Liverpool City Council

Liverpool Civic Place Stage B
& C

**Access Review –
Final**

10th December 2020

Basement 01

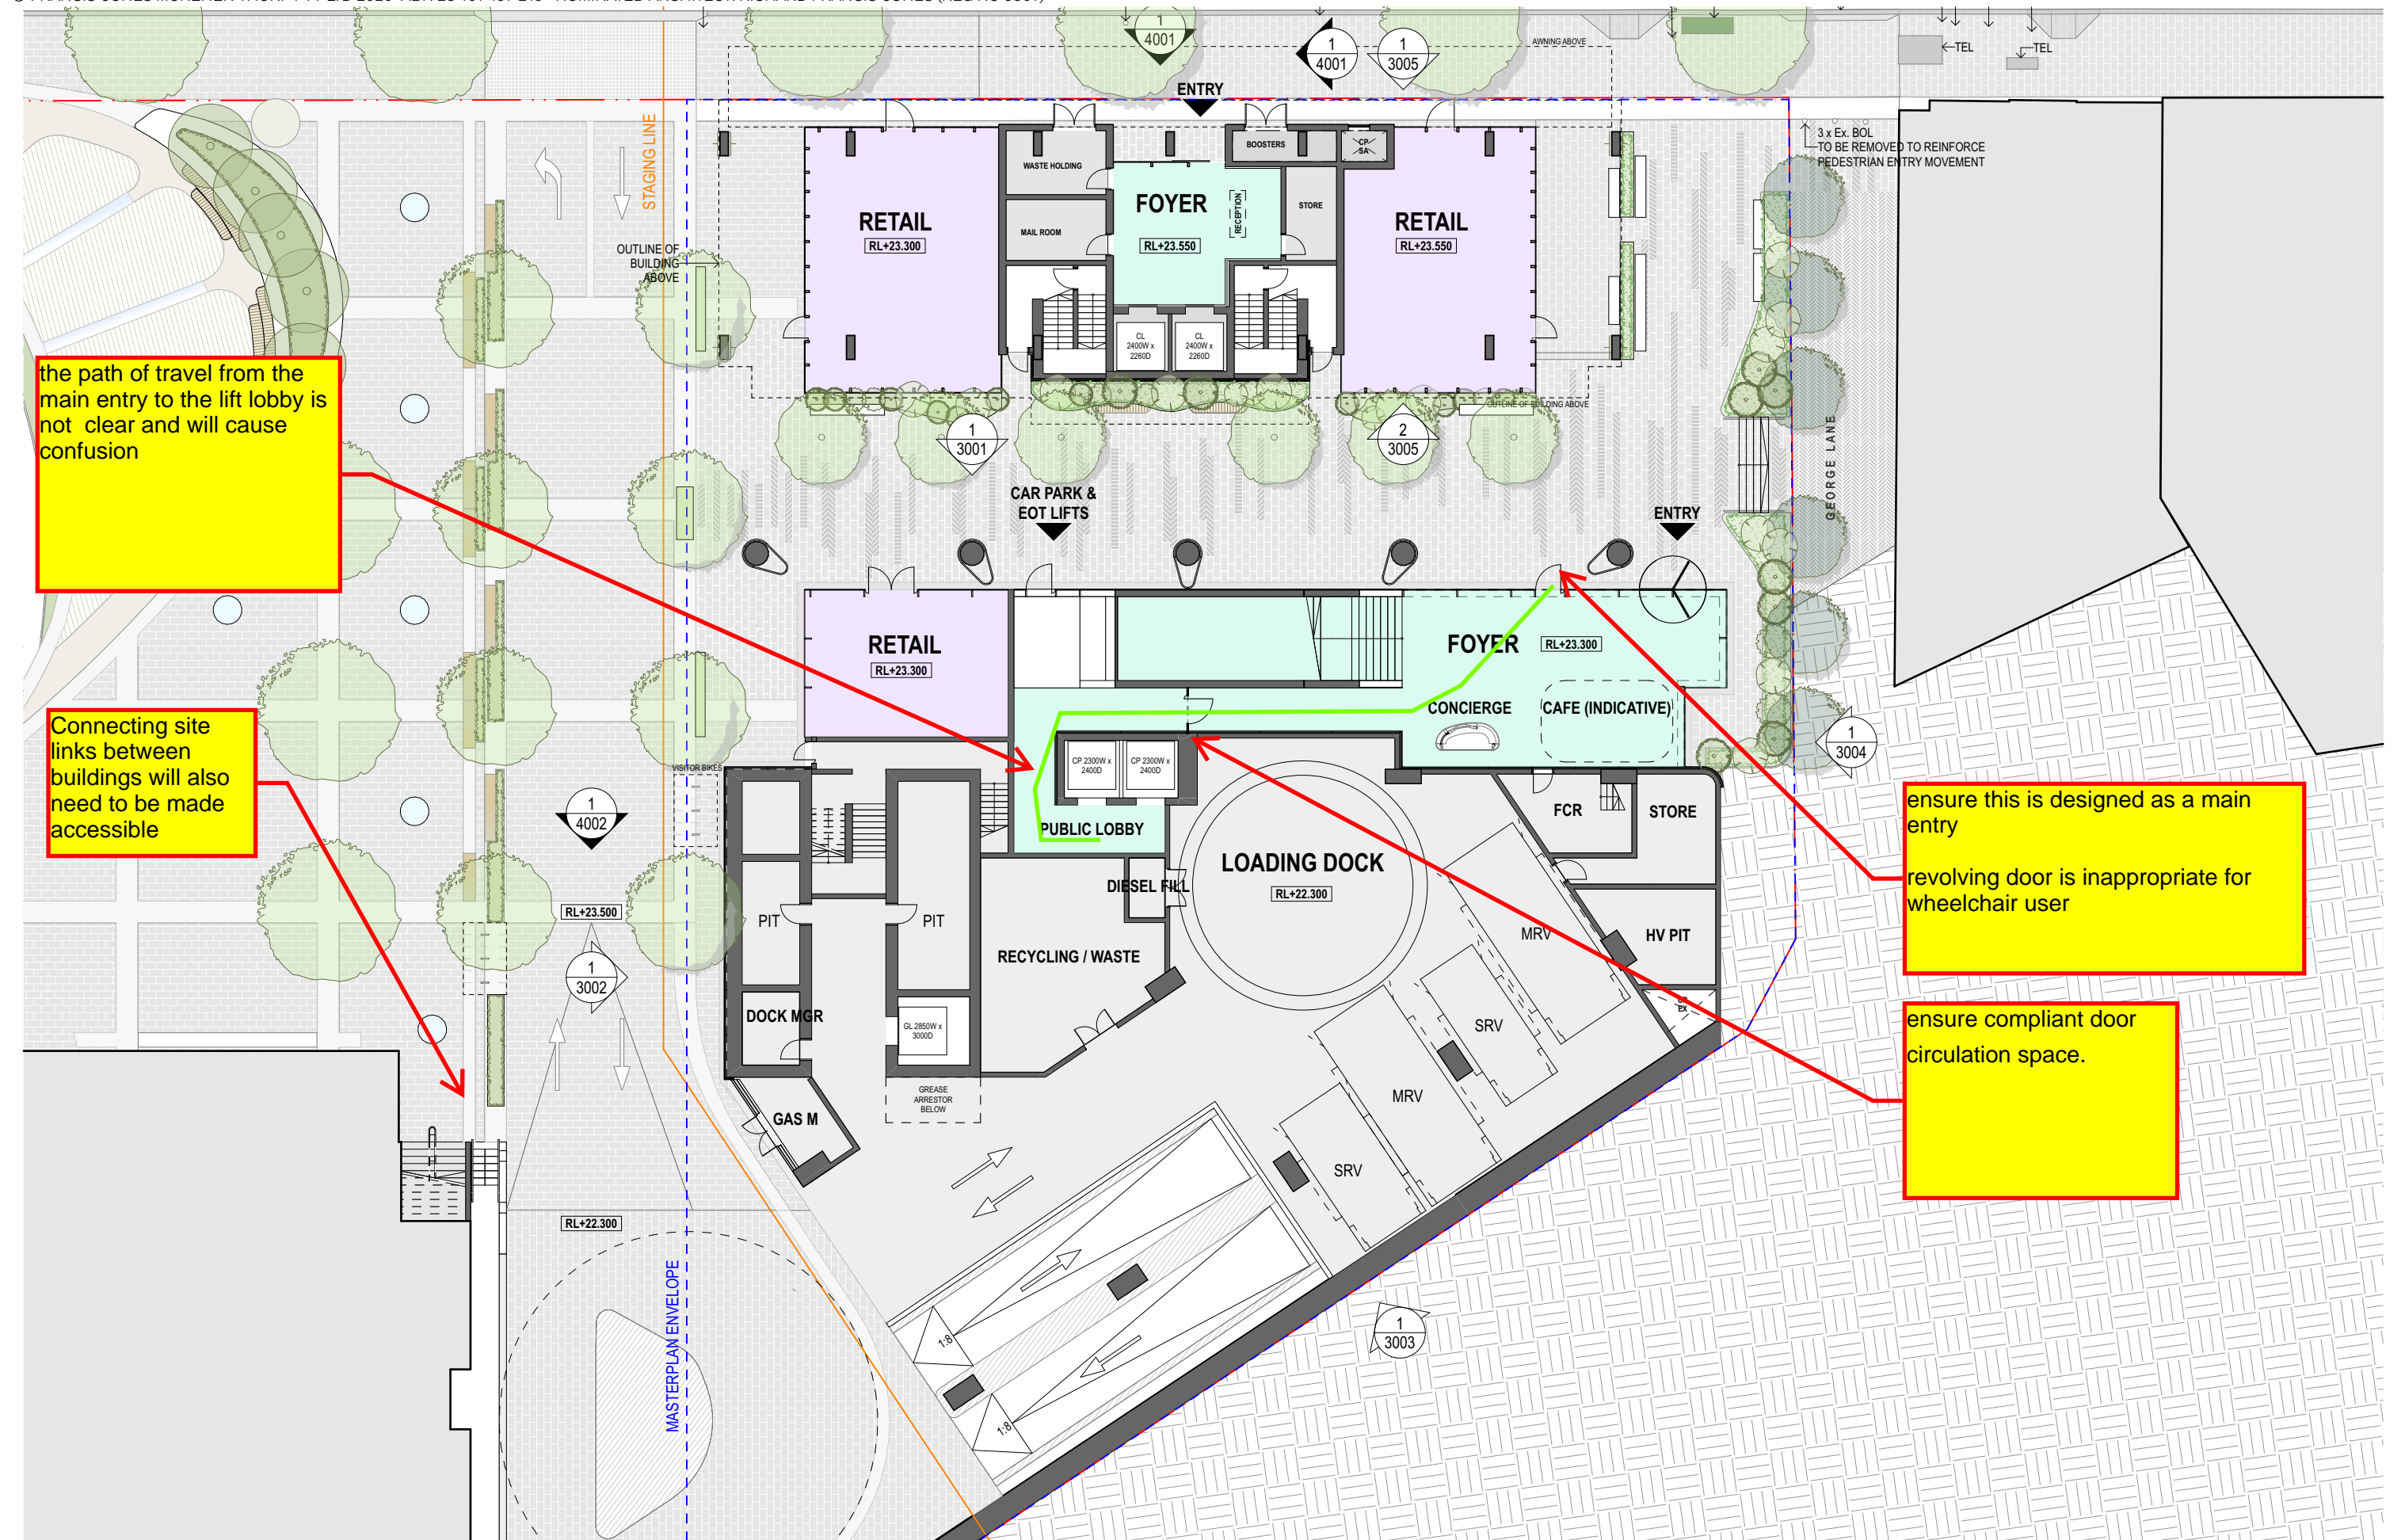
the path of travel from the main entry to the lift lobby is not clear and will cause confusion

Connecting site links between buildings will also need to be made accessible

ensure this is designed as a main entry
revolving door is inappropriate for wheelchair user

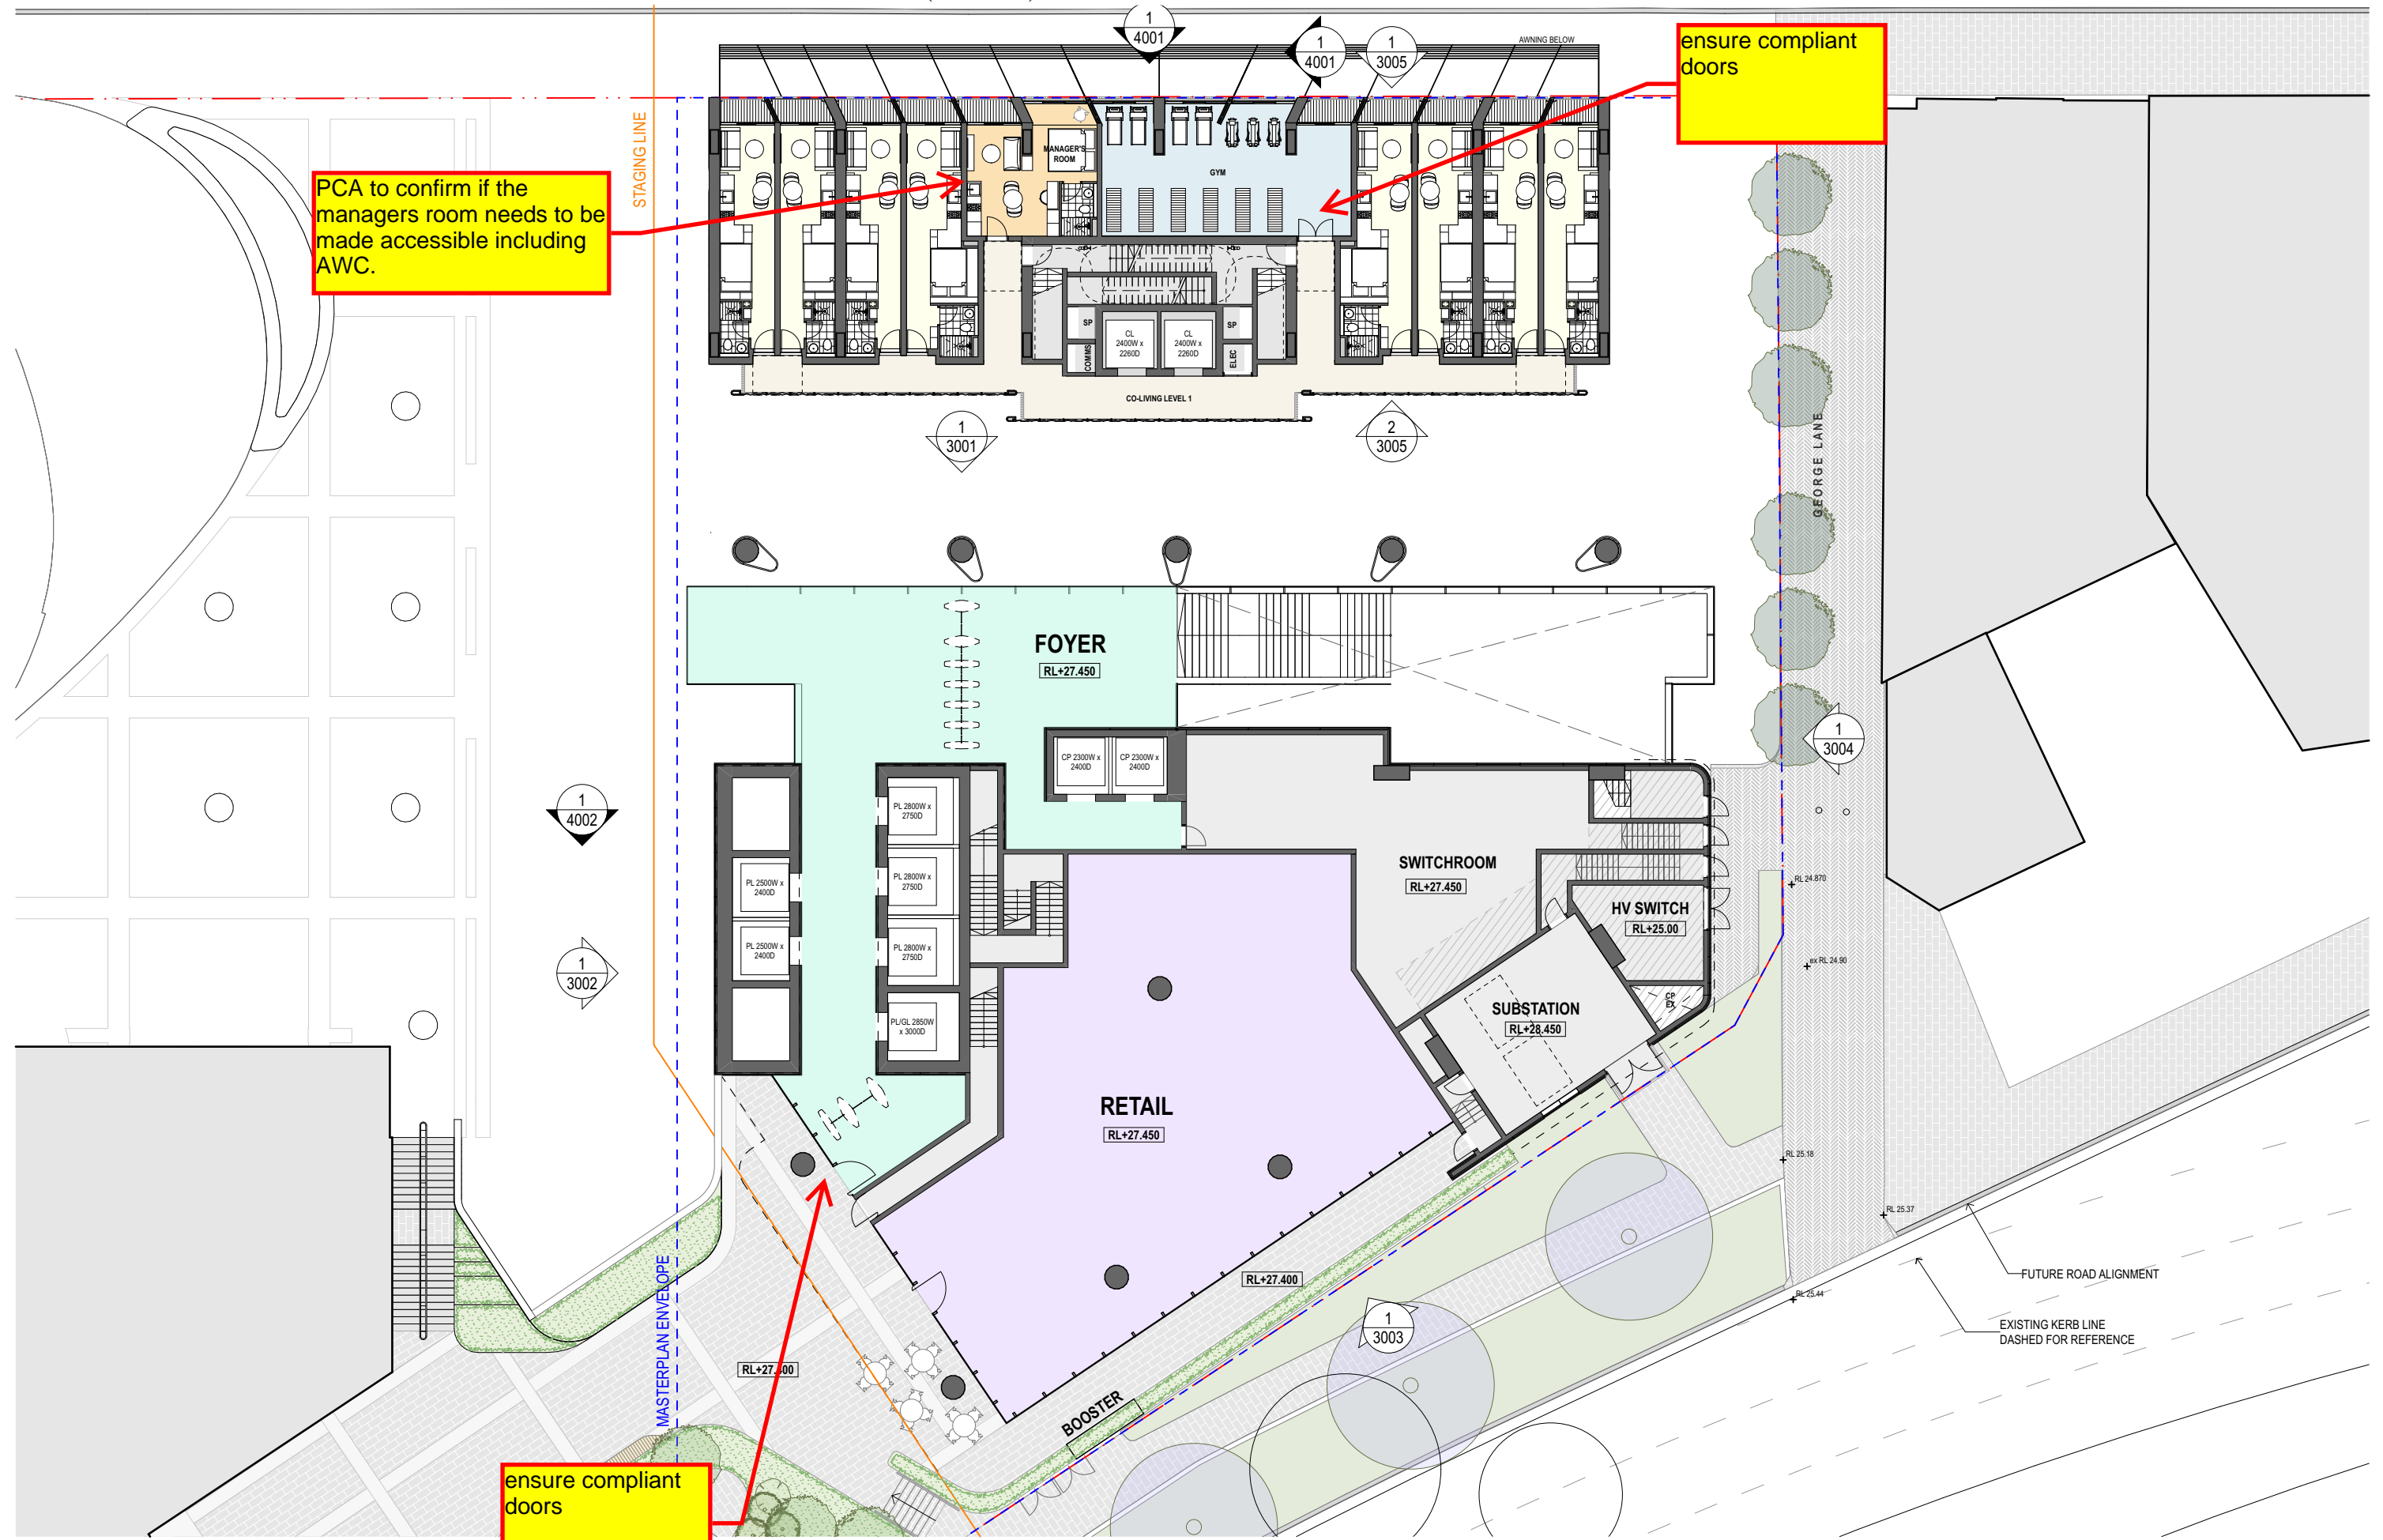
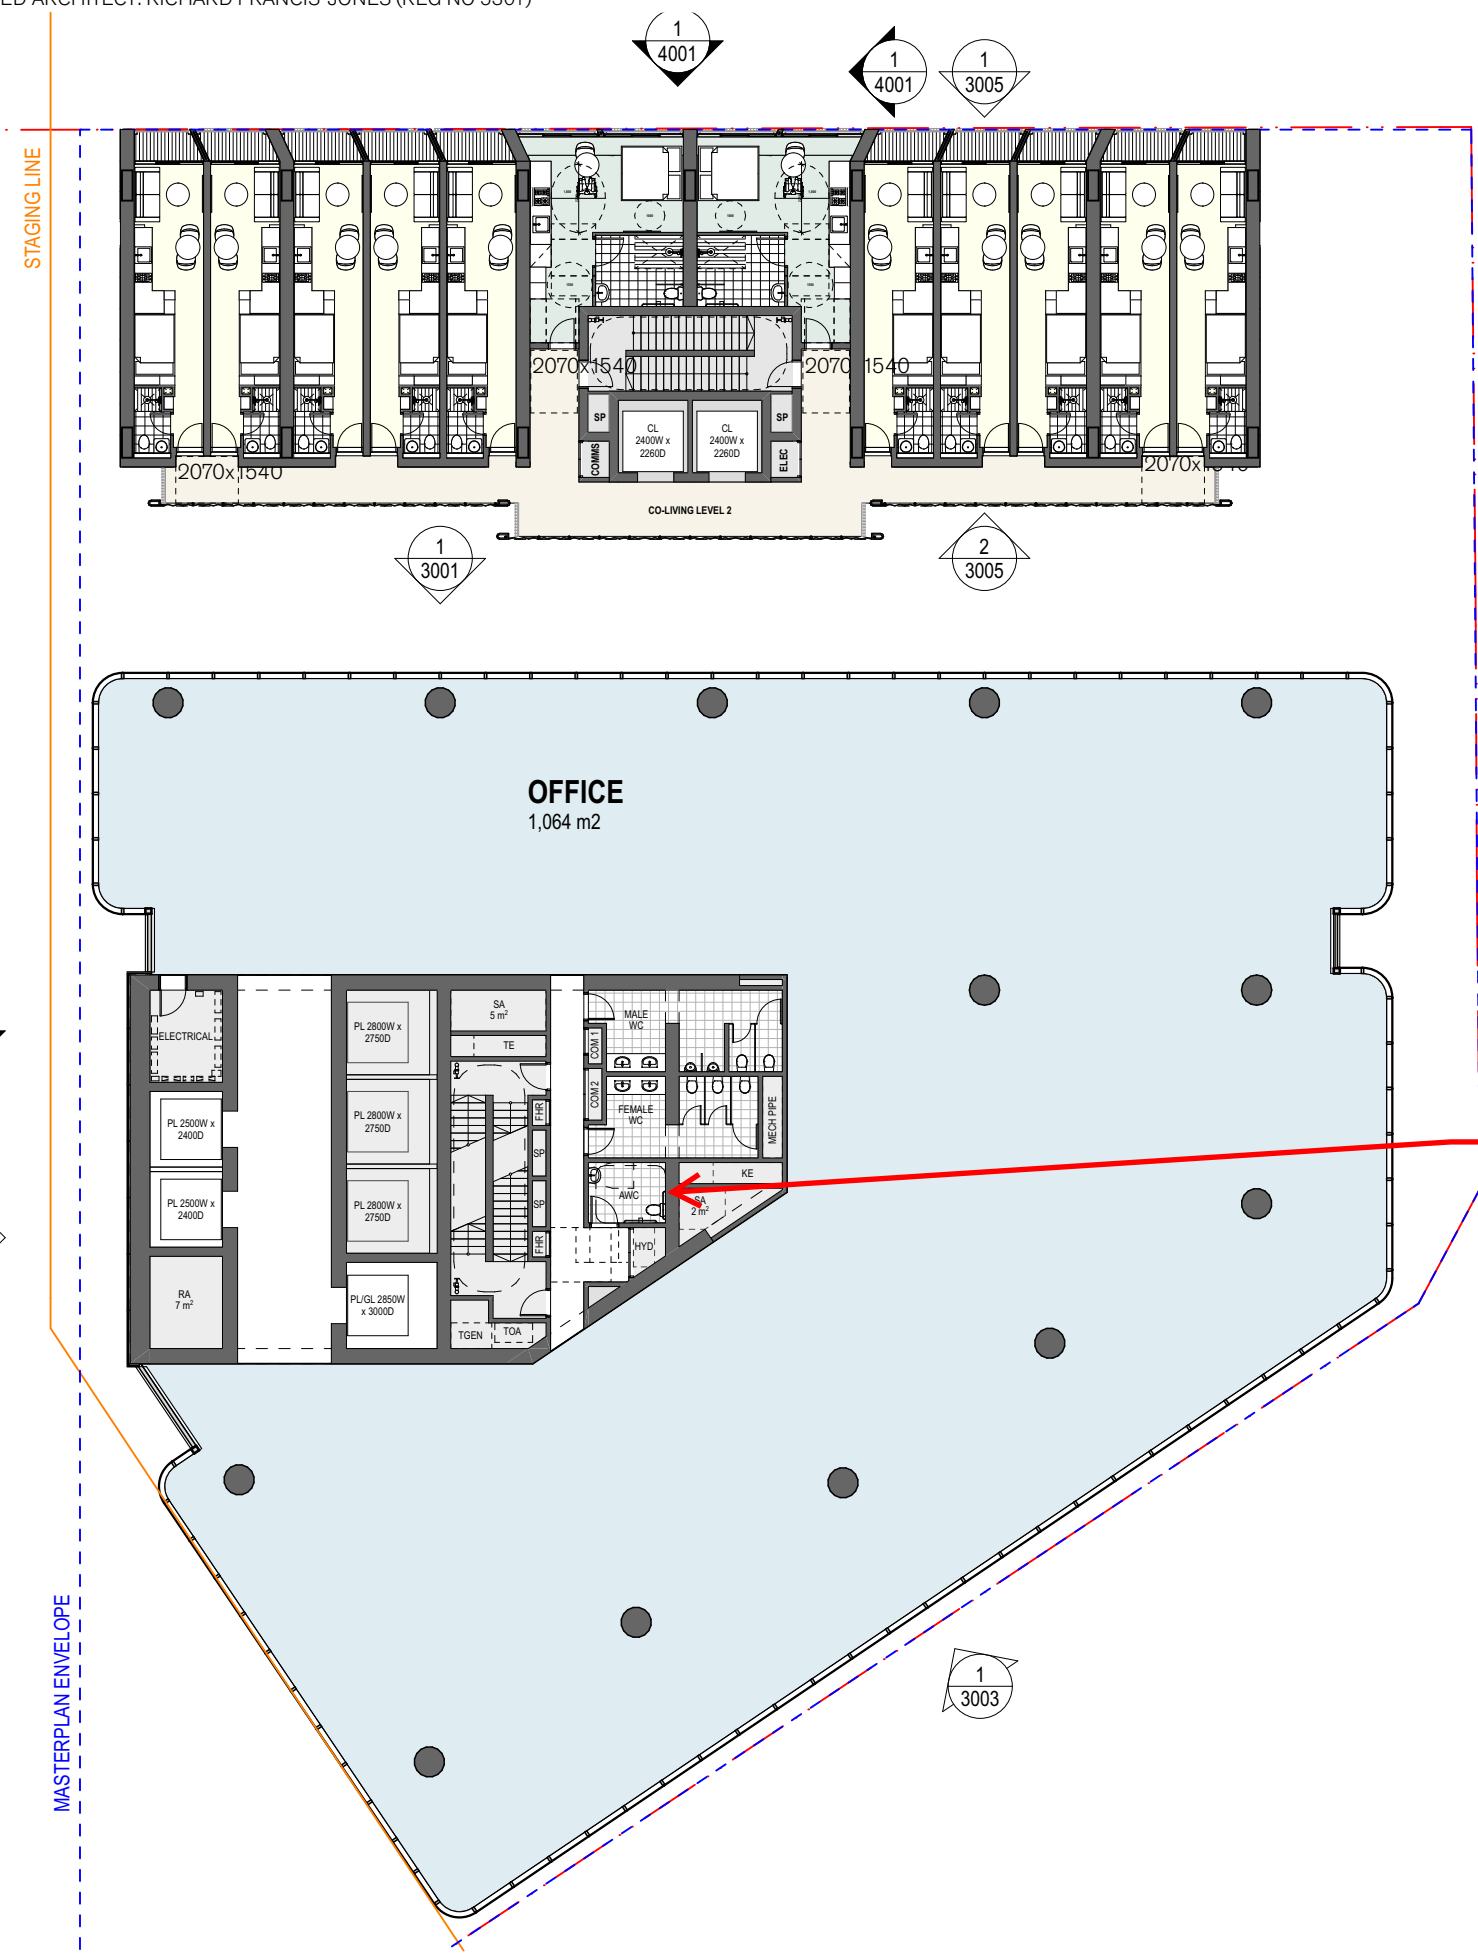
ensure compliant door circulation space.

MGAC Comments for accessible boarding rooms

1m clear width required either side of the bed

If applicable, level access required onto balcony.

ensure room length of min 2630mm

ensure 1m wide corridor is maintained
